July 07, 2022

This Addendum to the Invitation for Bid (IFB) serves to notify all interested bidders of clarifications and or changes to IFB No. P22002, and becomes part of this IFB. Proposers are required to acknowledge receipt of this addendum in their bid. If not acknowledged, Proposers' bid may be considered "non-responsive."

Elderly Development - Fresno Housing Authority  
 2415 5th St  
 Sanger, CA 93657

WEDBWOOD COMMONS  
KIT. REHAB DETAIL

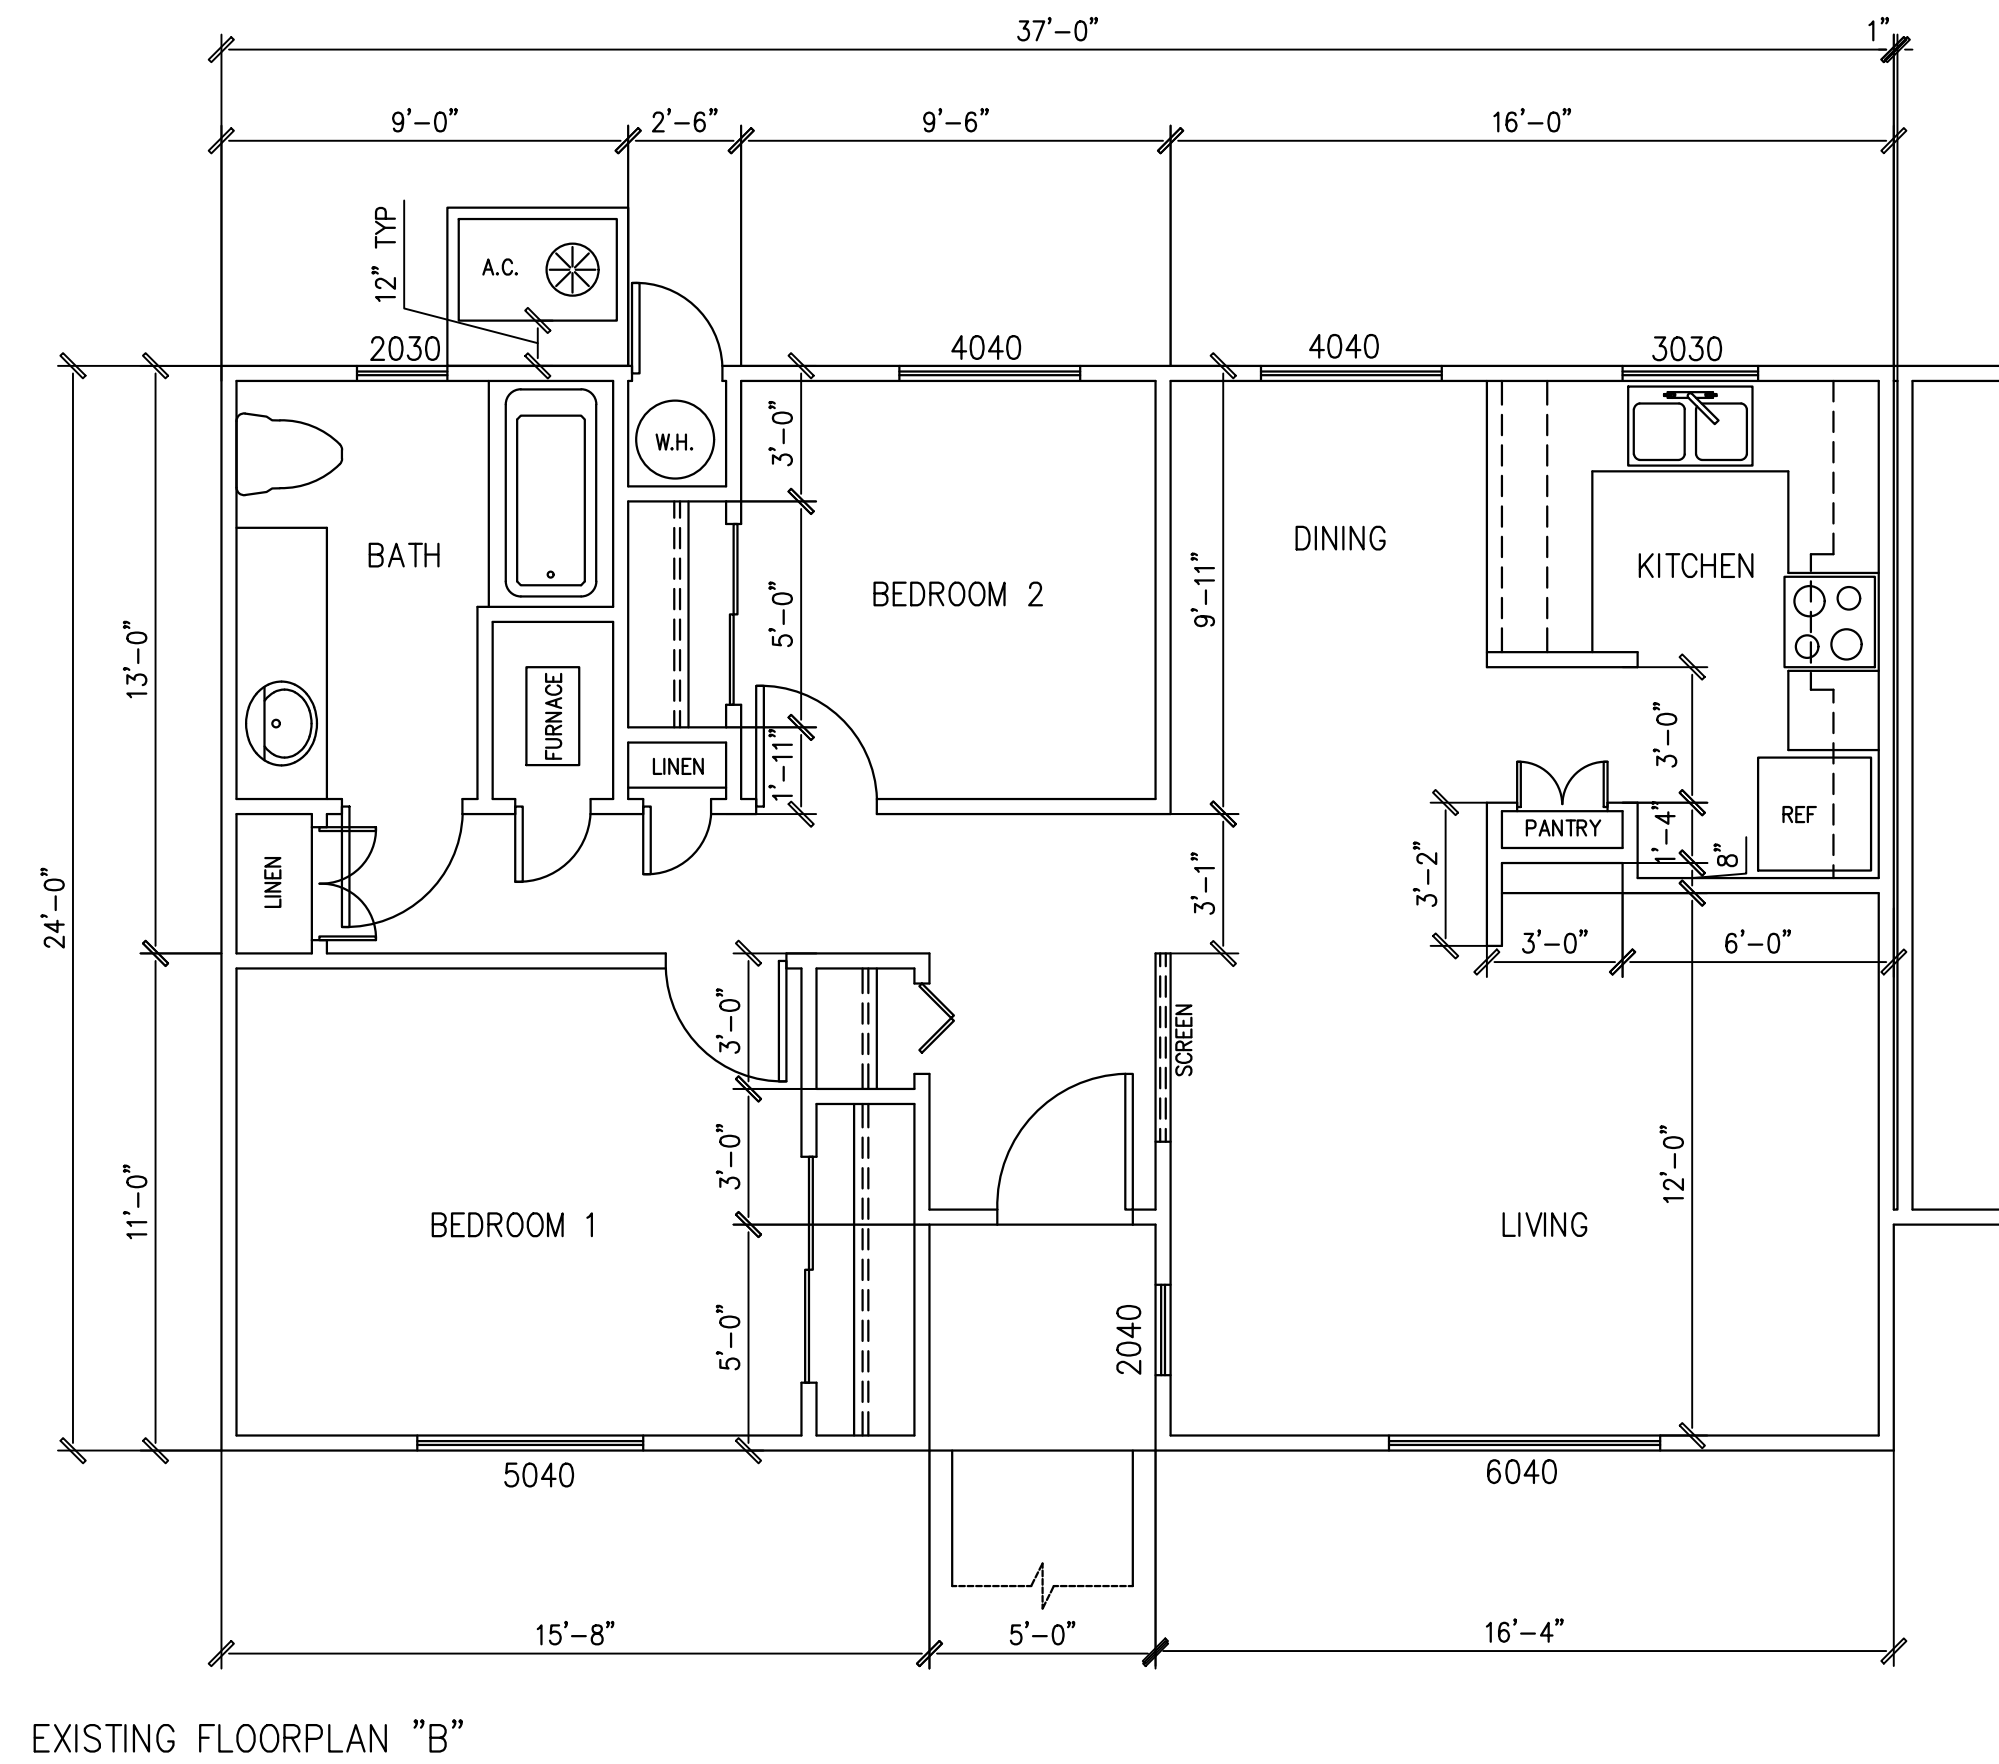
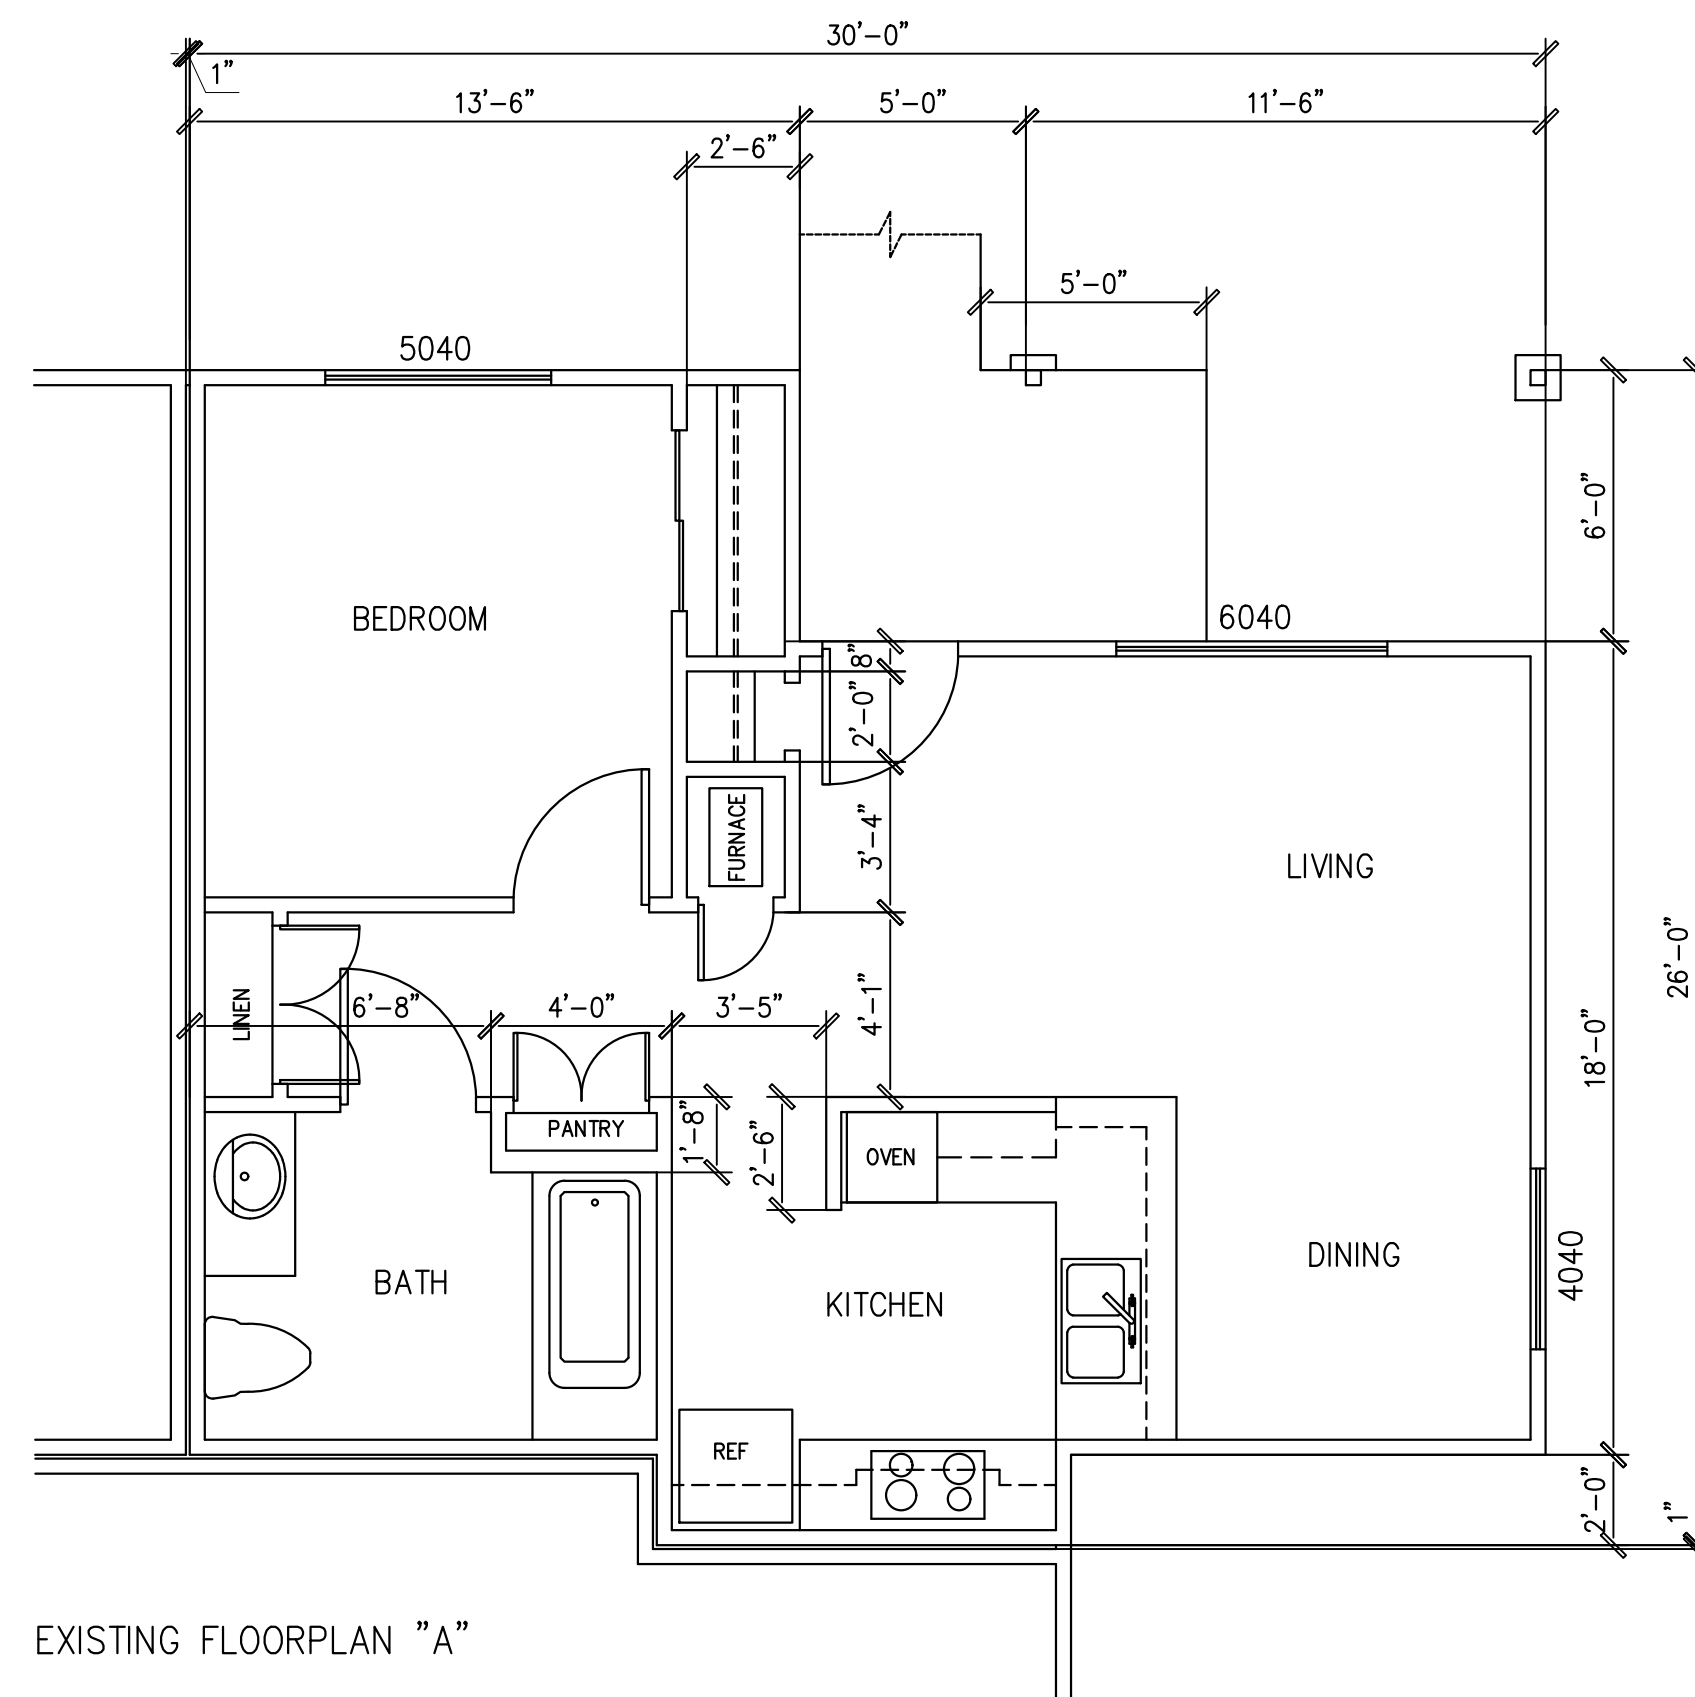
- REMOVE PANTRY
- EXIST. PANTRY CAB.
- REMOVE SHELVES IN LIB. REFRIG. and FINISH
- EXIST. LIB. REFRIG. SHELVES REMOVE
- NEW RCF LOCATION
- FRAME and FINISH WALL L12
- MOME Duplex RECEPT TO FRONT OF

- Replace kitchen cabinets that separate the kitchen and the dining room. Replace all kitchen cabinets upper and lower, except the upper cabinets between kitchen and dining room.

- Install new lower cabinets between the kitchen and dining room .5ft from the lower cabinets on the east wall where the stove is located.
  - Maintain 5ft clearance between the cabinets and bull nose between the cabinets as referenced above.

- Remove the existing pantry cabinets, trim, walls and living room. Shelves as needed for the installation of the existing refrigerator.
- Move/cut and frame walls to accommodate the existing refrigerator.

- Frame and finish walls as needed in living room and refrigerator cavity.
- Relocate duplex receptacle towards the front of the refrigerator wall for accessibility.

- Install new duplex receptacle on the new cabinet wall facing the dining room.
- Install switches for the range hood and light in the front of the new cabinet meeting ADA requirements.

- Relocate the light switches from the kitchen wall being removed to the refrigerator wall facing the living area to the west as close to the front of the refrigerator cavity wall.
